8920A-02A

S E R V I C E N O T E

HP 8920A RF Communications Test Set

Early Instruments Require Firmware Upgrade

Figure - 1

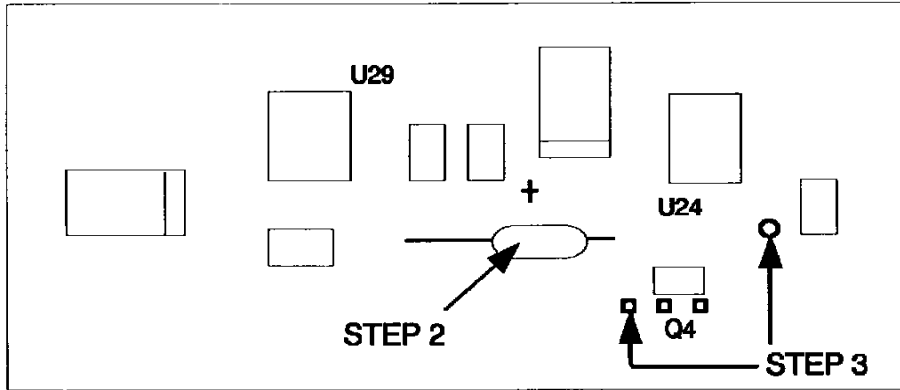
Instruments with these serial prefixes have an A7 Controller assembly that is incompatible with the new A8 Memory assembly which is required to upgrade the firmware.

1. Remove the A7 Controller (DCU) assembly from the instrument. Locate the area of the board shown in Figure 1.
2. Remove the diode in this location and install a 2.87 Kohm resistor.
3. Install a 1 Kohm resistor on the backside (circuit) of the board between these 2 feedthrough holes. Scrape the solder resist off the pads on both sides of the board on the feedthrough hole to the left of the surface mount resistor. Clear the solder out of the feedthrough hole to the left of Q4. It's a tight fit, but the leads will go through the holes.

Figure - 2

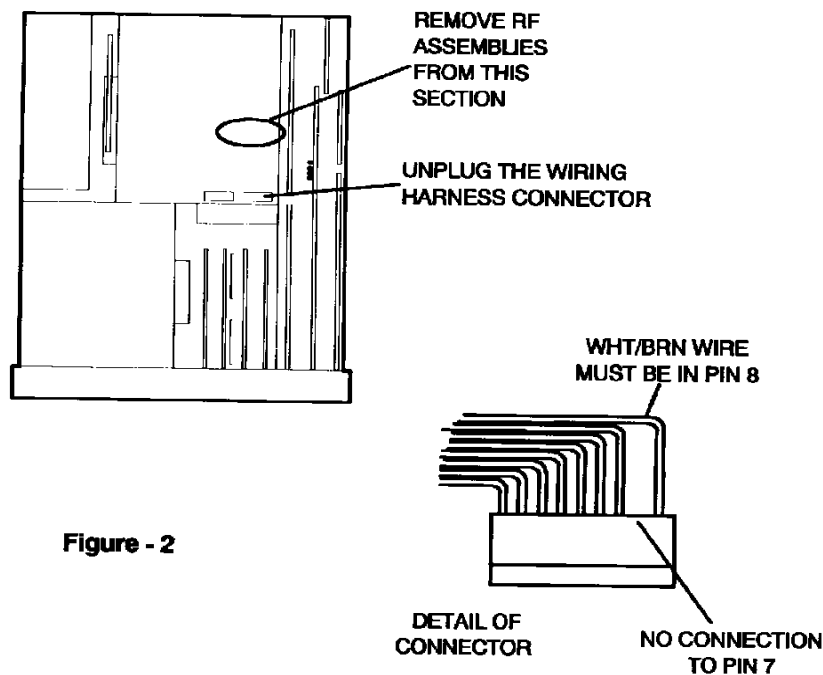
Instruments in this serial prefix range have an error in the main Power Supply wiring harness. This error prevents the processor from identifying whether the power supply is powered in AC or DC mode which prevents detection of a low battery condition.

1. Remove all the RF assemblies from the instrument.
2. Unplug the wiring harness connector shown in Figure 2.
3. The WHT/BRN wire should connect to pin 8 of this connector. See Figure 2. If the WHT/BRN wire is connected to pin 7, it must be moved to pin 8. There should be no wire connected to pin 7.
4. To move the wire insert a small sharp pointed tool into the cutout on the side of the connector body next to the pin to be moved. This should allow the wire to be removed from the connector body. Then insert the wire into the pin 8 position of the connector body.
